MPC Paper No. A/K5/796
for Consideration by the
Metro Planning Committee
on 3.8.2018

**APPLICATION FOR PERMISSION
UNDER SECTION 16 OF THE TOWN PLANNING ORDINANCE**

APPLICATION NO. A/K5/796

Application : Proposed Office Building with Shop and Services

| 參考編號 REFERENCE No. A/K5/796 | 繪圖 DRAWING A-3 |

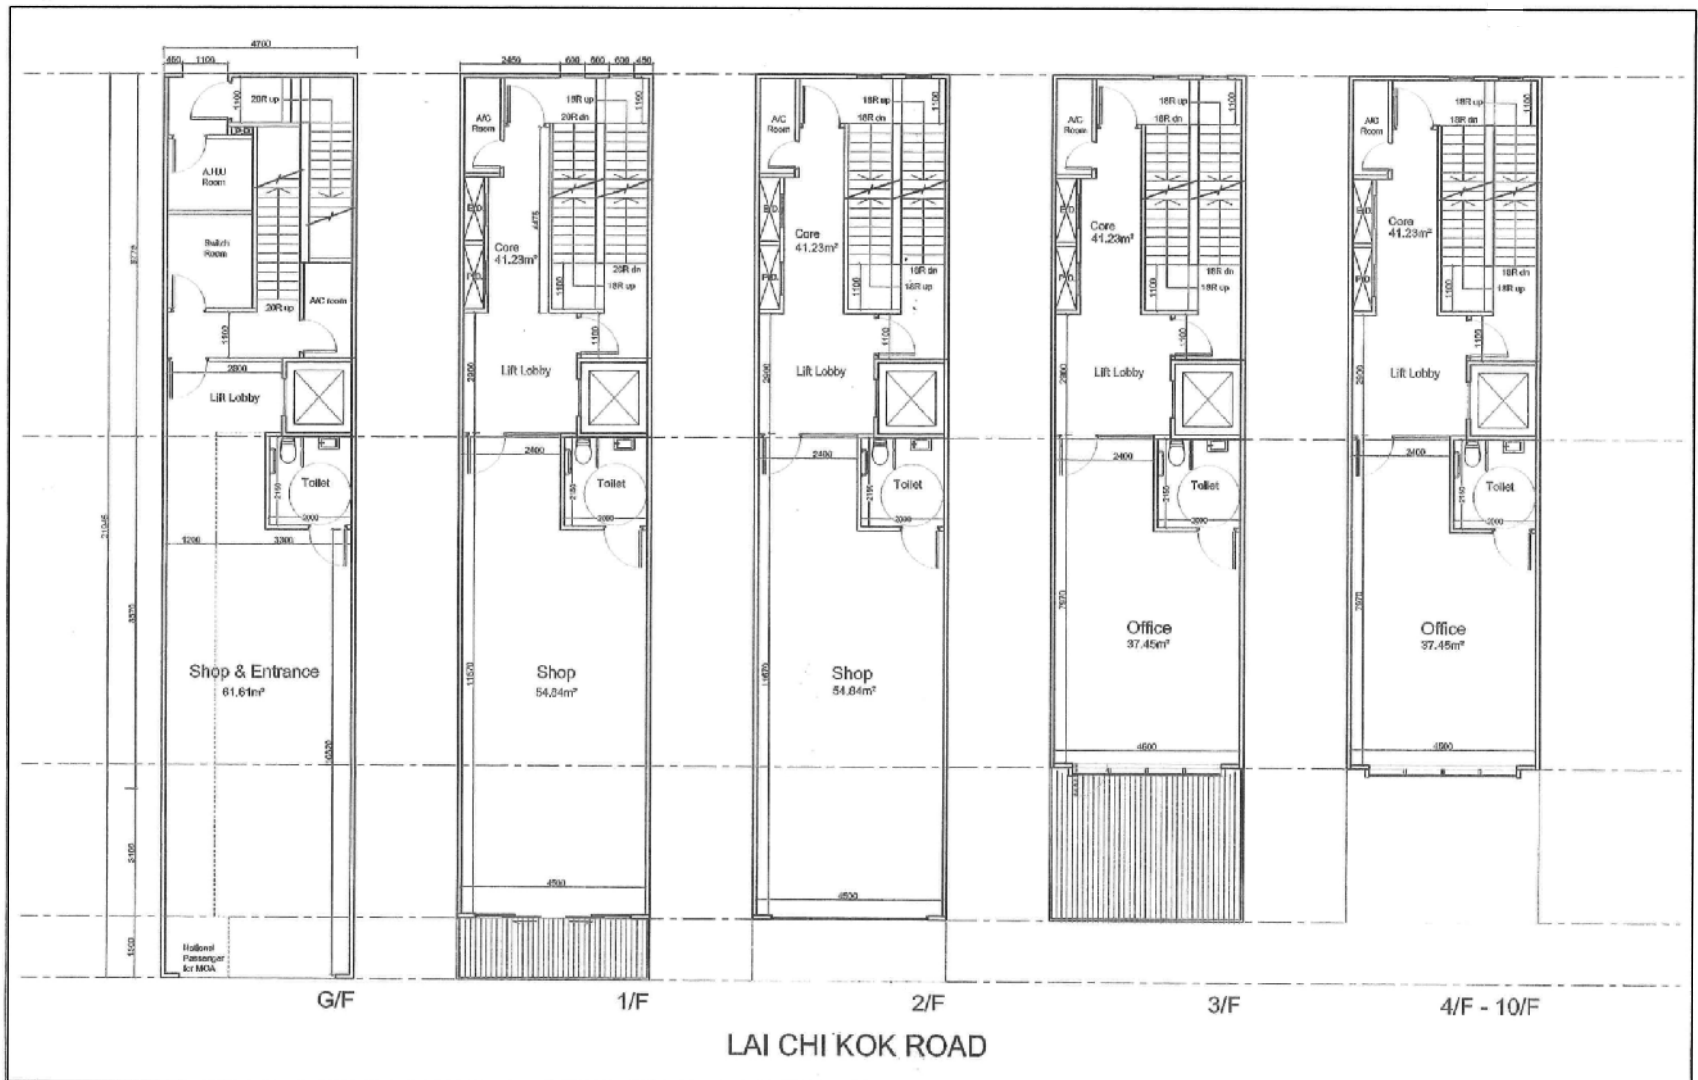
- (a) under the option for residential development at the Site based on site coverage (SC) of 42% of domestic building with BH over 30m but not exceeding 36m, the residual area for residential uses on upper floors of the proposed building shall be 1.96m² after the deduction of the minimum core area of 41.23m² (including two escape staircases and one firemen lift with adequate protected lobby for compliance with the requirements under the Buildings Ordinance (BO)) (**Annex 4** and plan at **Appendix C** of **Appendix I**). However, the residual area for office development on the upper floors of the proposed building shall be 37.45m² after the deduction of the minimum core area (**Drawing A-3**) based on SC of 77% for the same BH. As such, the Site is not

- (iv) natural lighting and ventilation should be provided to the proposed office development in accordance with B(P)R 30 and 31.
- (c) Regarding the proposed layout of the development, his comments are as follows:

- (i) protected lobby to escape staircase shall be provided in accordance with Clause B10.4 of FS Code;
 - (ii) fireman's lift lobby shall be designed and compliance with Clause D11 of FS Code; and

- (iii) he has no comment under the BO regarding the "minimum core areas" of the proposed development.
- (d) Detailed comments under the BO can only be provided at the building plan submission / licence application stage.
